JAFP-16-0192
December 22, 2016

Subject: Entergy – James A. FitzPatrick Fifth Six-Month Status Report in Response to June 6, 2013 Commission Order Modifying Licenses with Regard to Reliable Hardened Containment Vents Capable of Operation Under Severe Accident Conditions (Order Number EA-13-109)

James A. FitzPatrick Nuclear Power Plant
Docket No. 50-333
License No. DPR-059

**James A. FitzPatrick (JAF) Nuclear Power Plant's Fifth Six Month
Status Report for the Implementation of Order EA-13-109, "Order to
Modify Licenses with Regard to Reliable Hardened Containment Vents
Capable of Operation Under Severe Accident Conditions"**

Sketch 3: FLEX / SAWA Equipment Location

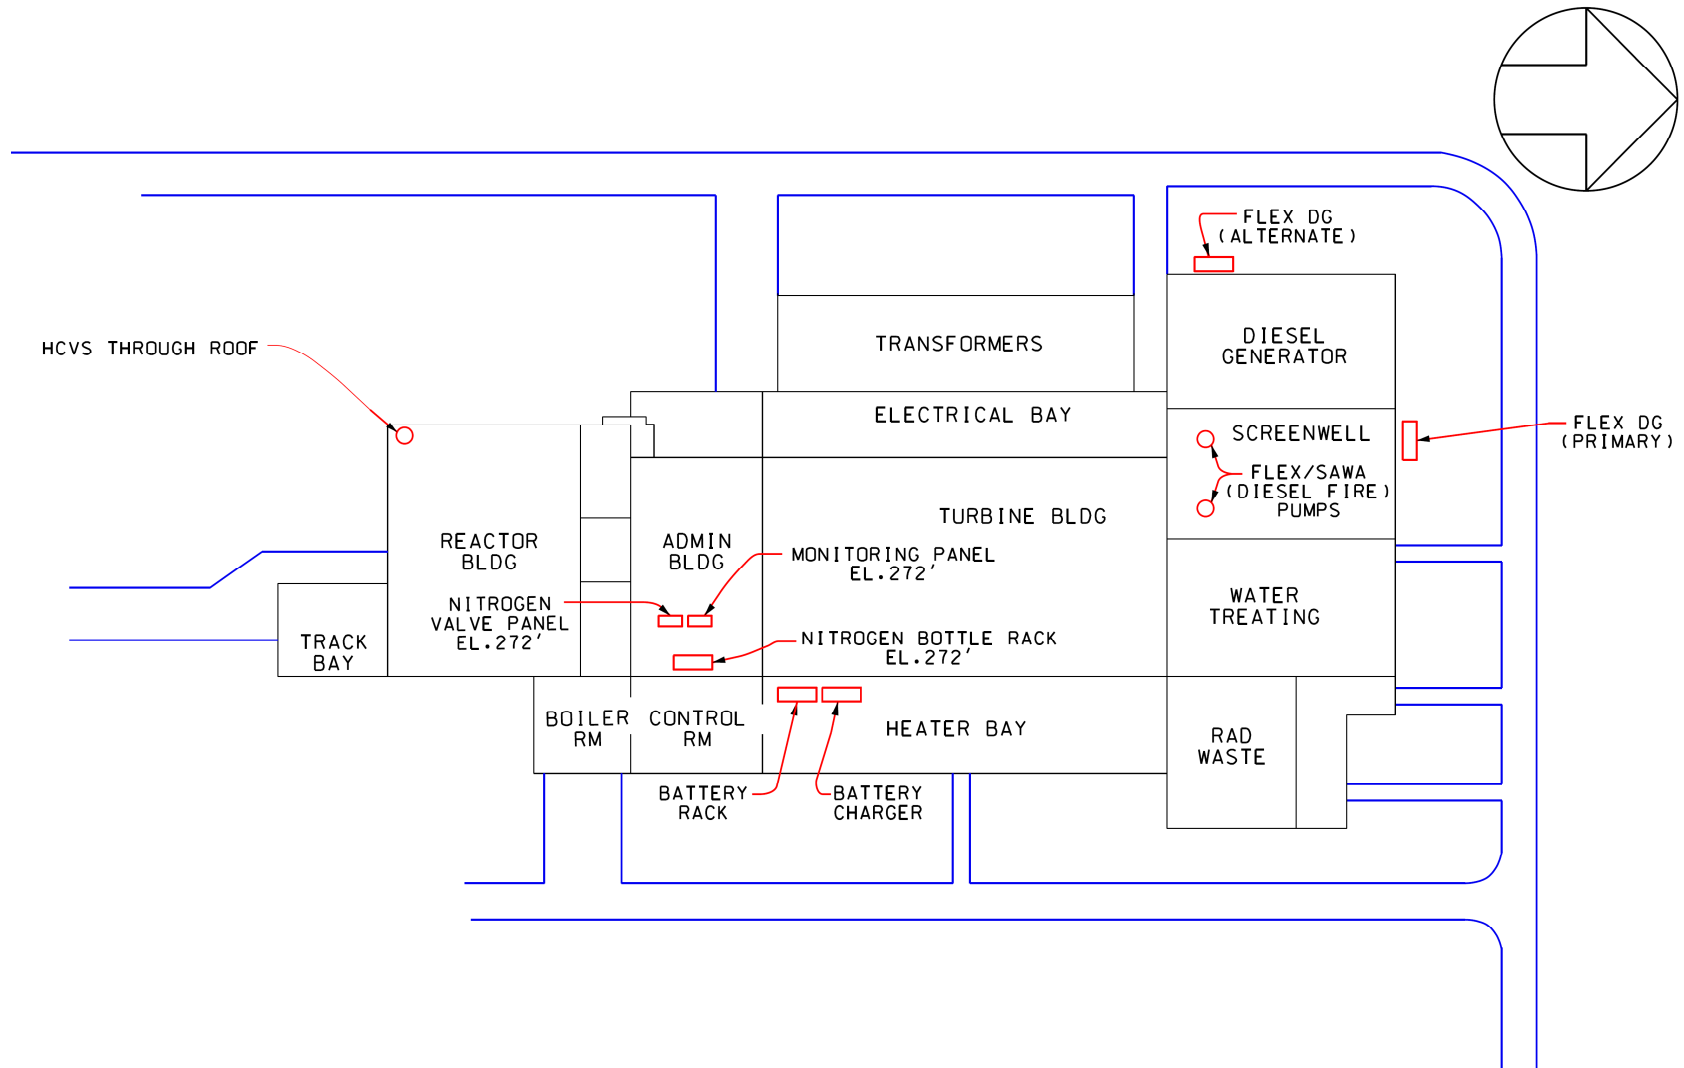
Phase 2 Overall Integrated Plan (Reference 3): Sketch 3 FLEX / SAWA Equipment Location; Order EA-13-109 (Reference 1) Item 1.2.8, 2.1, 2.2, 2.3

The primary and alternate locations of the FLEX / Severe Accident Water Addition (SAWA) diesel generators have been switched. Sketch 3 has been updated to reflect this change.
